Memorandum

Project #: 14319.00

Re: 1114 Beacon Street Redevelopment
Response to Transportation Peer Review Comments
Memorandum by BSC Group, Inc., dated May 4, 2020

Architectural Plan showing Bike Repair/Storage Room

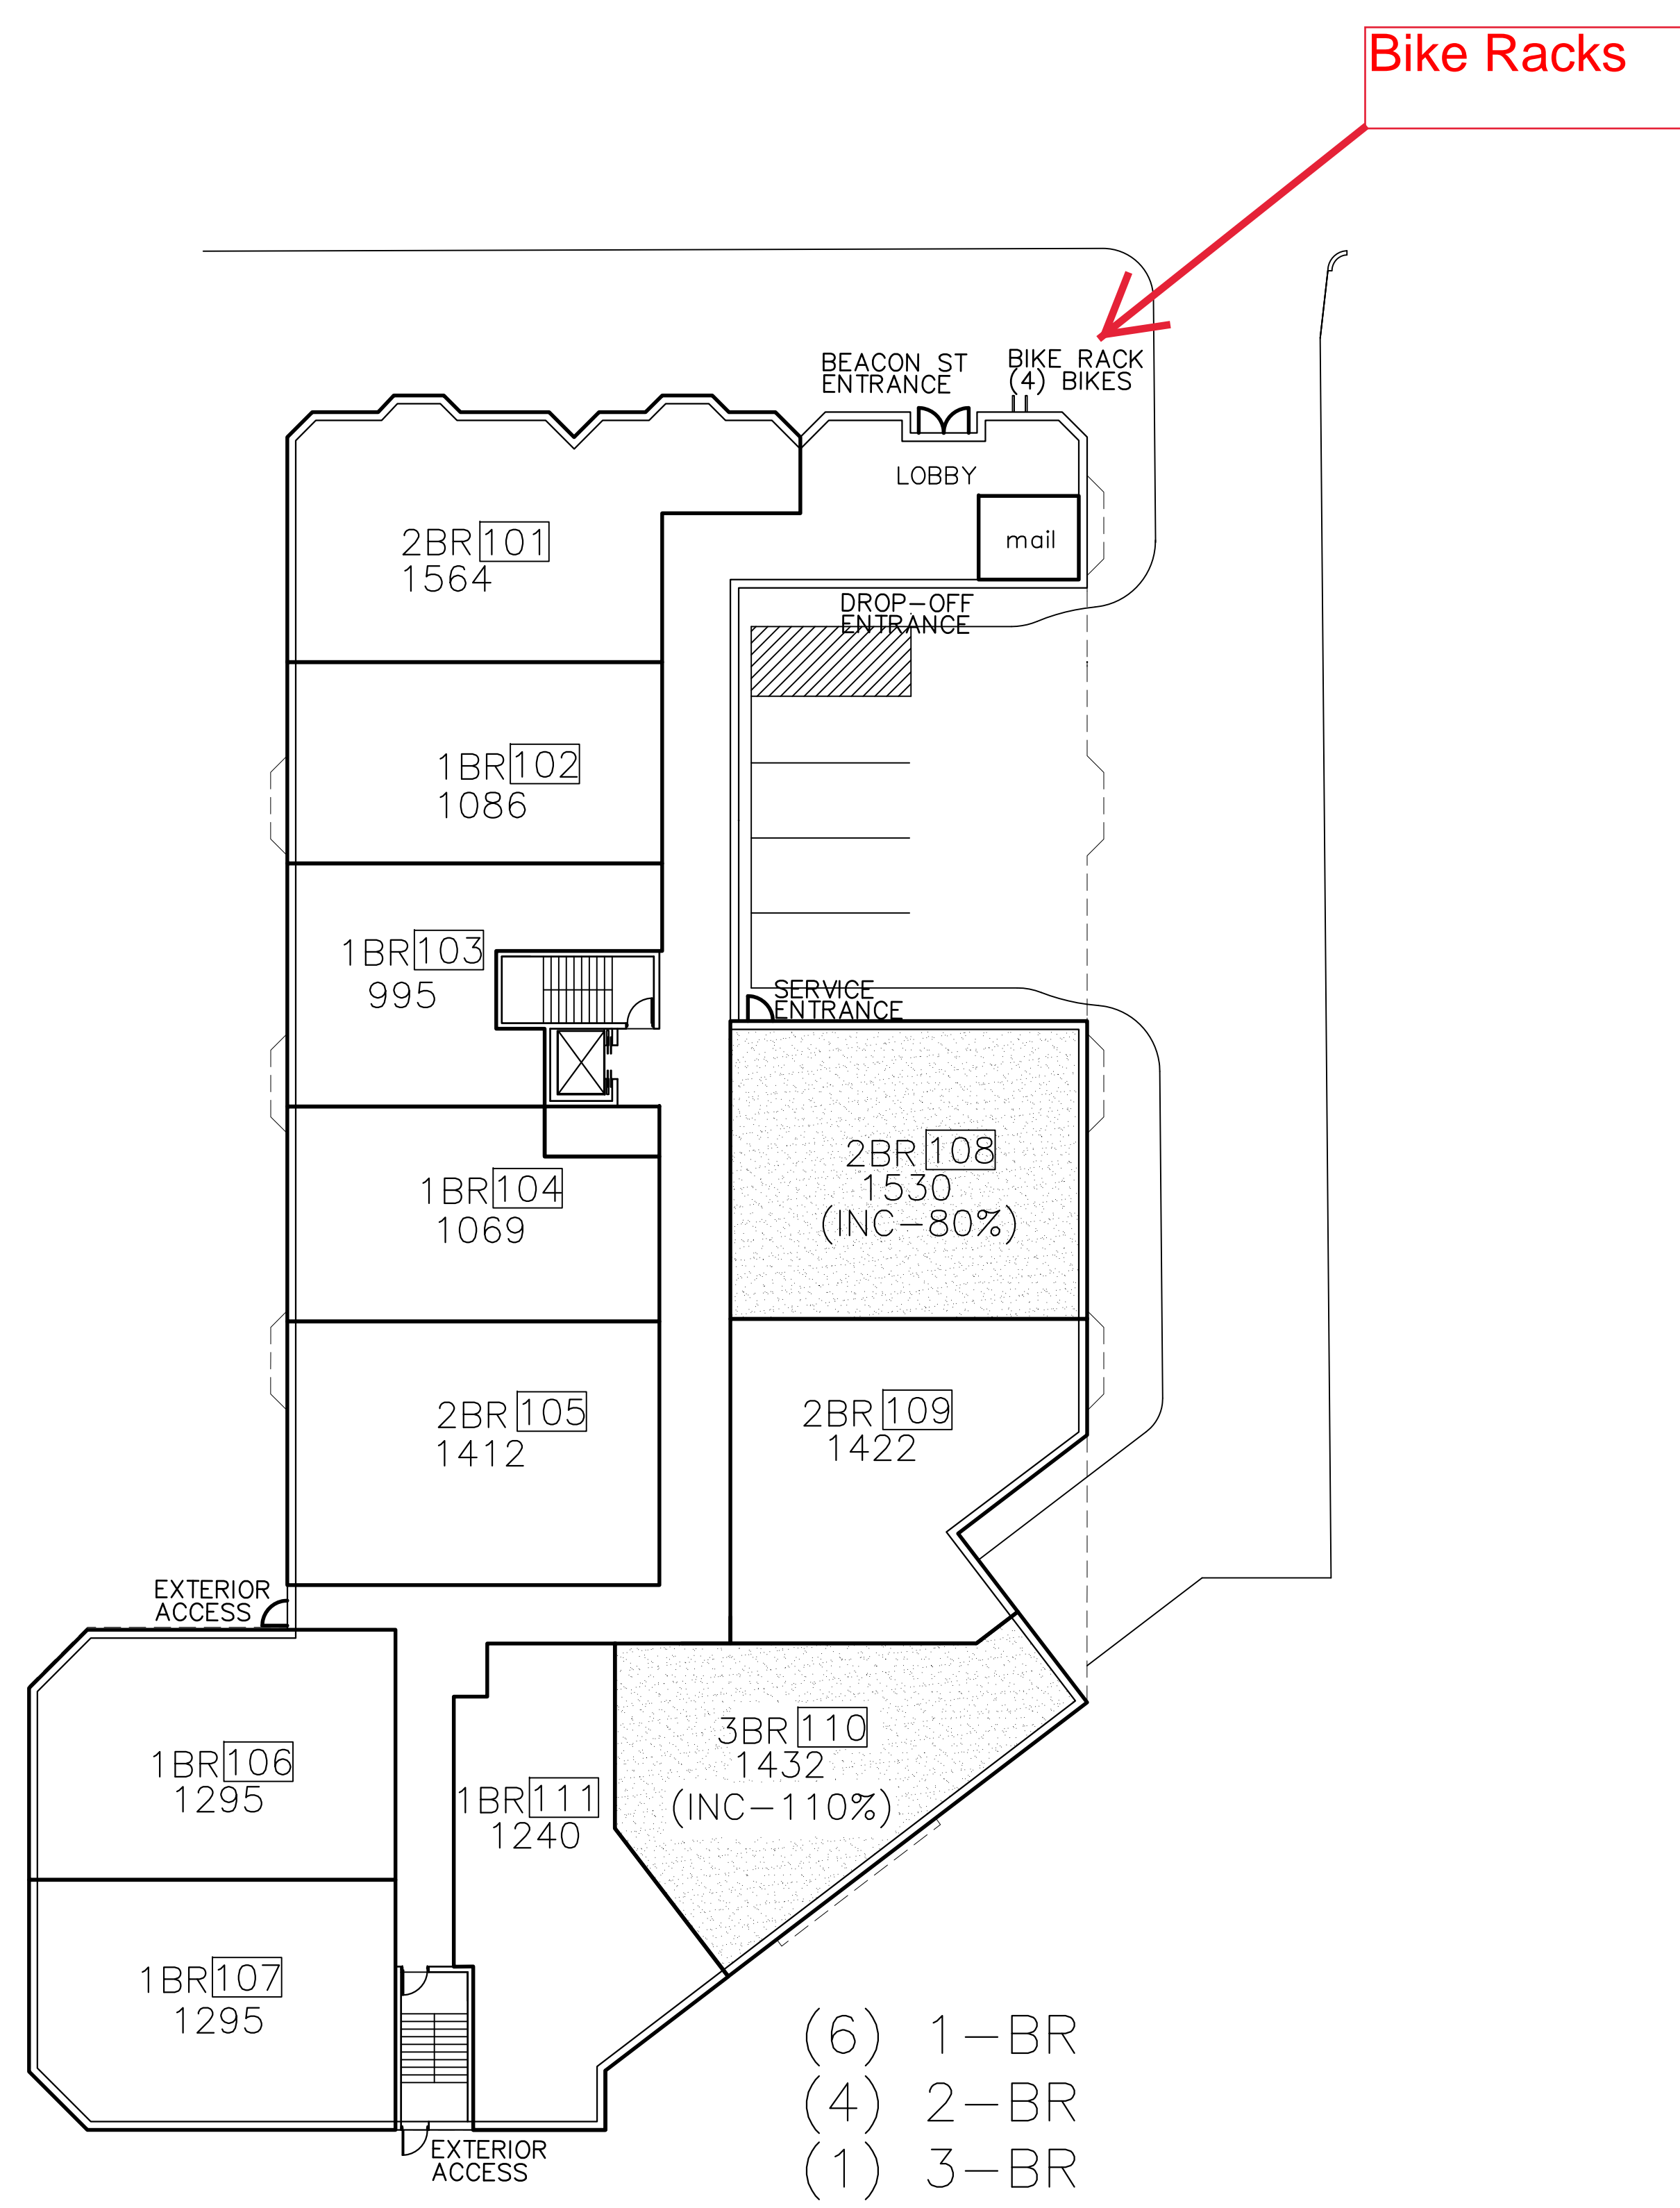
Comment 18: BSC requests that the Applicant describe the bicycle storage room including the proposed location within the building, size of room, and type of storage devices that will be used.

Response 18: The bike storage/repair room is located on the garage level (northeast corner). The room is 20 feet by 25 feet and is designed to accommodate 20 bicycles. A bike rack will also be installed outside (north east corner of building along Beacon Street) that can accommodate 4 additional bicycles. In addition, two additional bike racks will be installed per parking space should the buyer want that in their parking space. Plans showing these locations in detail are provided as an attachment to this document.
